# **Review of Model Plans for the John F. Baldwin Ship Channel Project**

Final report

Prepared for U.S. Army Engineer District, San Francisco  
San Francisco, CA 94105-1905

Figure 25

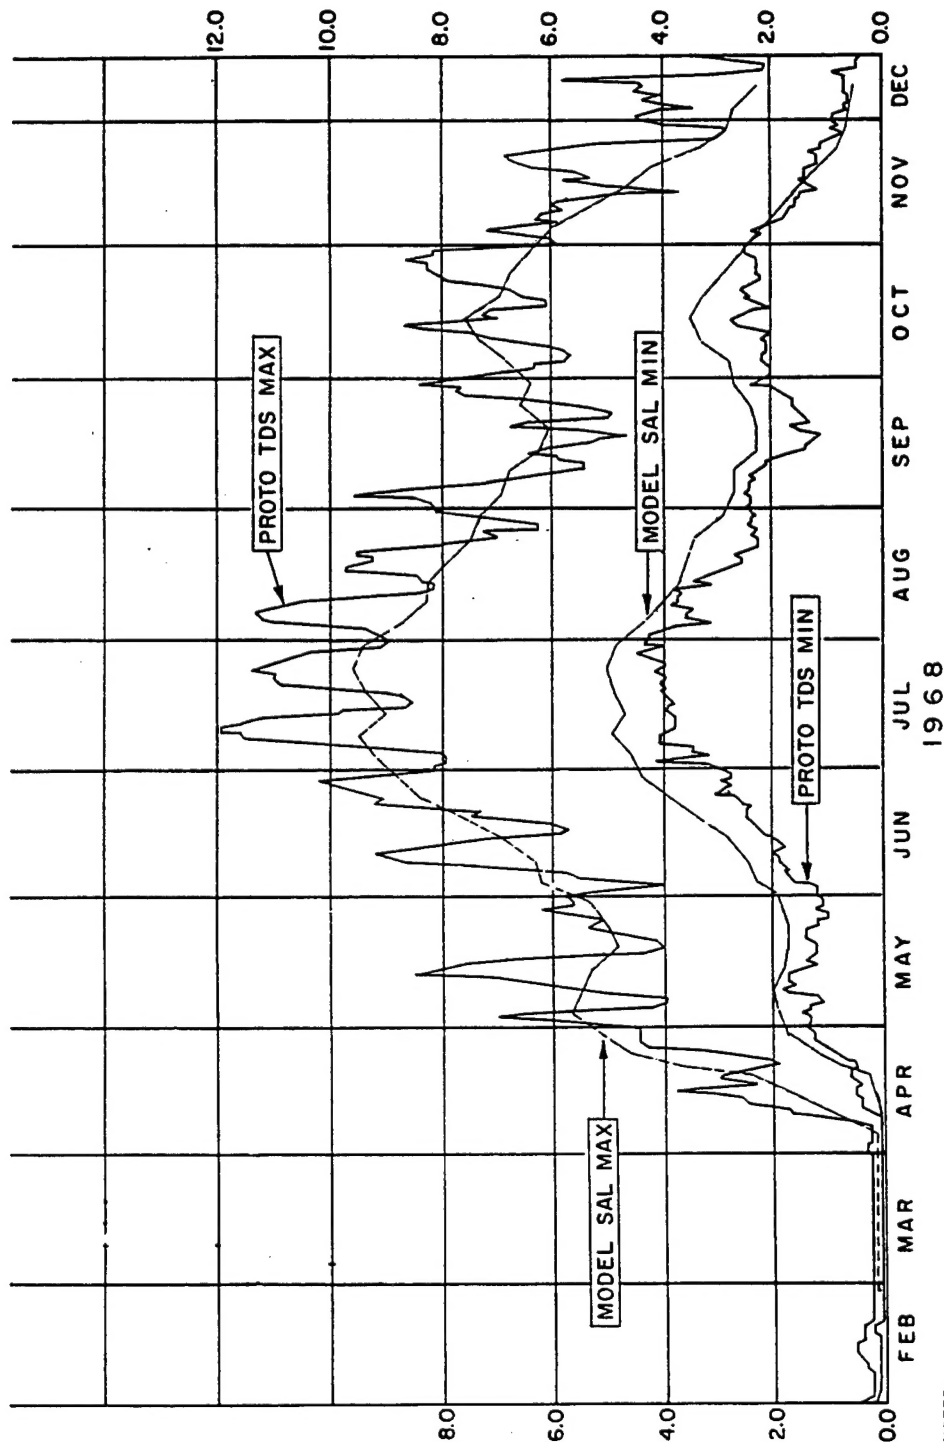
Comparison of modeled salinities using a repeated mean tide and prototype salinities at Pittsburg is shown by Figure 25 from Reference (1). This figure shows that the spring/neap cycle causes significant variations in the maximum salinities that occur during a tidal cycle (as much a 100% at this location). The water projects are managed on a tidal basis and changes of salinity during the spring/neap cycle may become more important to water transfer operations as restrictions on water diversion increase. Further, the maximum salinities during the spring/neap cycle may impact the quality of water in Delta channels.

The averaged model salinities plotted in Figure 25 also have a smaller maximum-minimum range than have the prototype salinity variations. This difference can be due to differences of vertical mixing by a repeated mean tide and those produced by a spring/neap cycle. Similar effects can be expected at lower salinities upstream. It can be concluded that facilities that provide a variable tide would significantly enhance the accuracy of model predictions and would make model tests more useful for water agency operation studies.

A repeated spring/neap tide cycle would be a step toward a real prototype boundary condition and may be appropriate during model adjustment. However, a runup using recorded or predicted tides prior to an event of particular interest to regulatory agencies may be required to meet their concerns.

Concerns that lead to the recommendations for a variable tide include concern for the effect of antecedent tides on mixing and longitudinal transport, as well as for the range of salinities. Repeated spring and repeated neap tides would not provide convincing predictions of salinity intrusion impacts of the J.F.B. project.
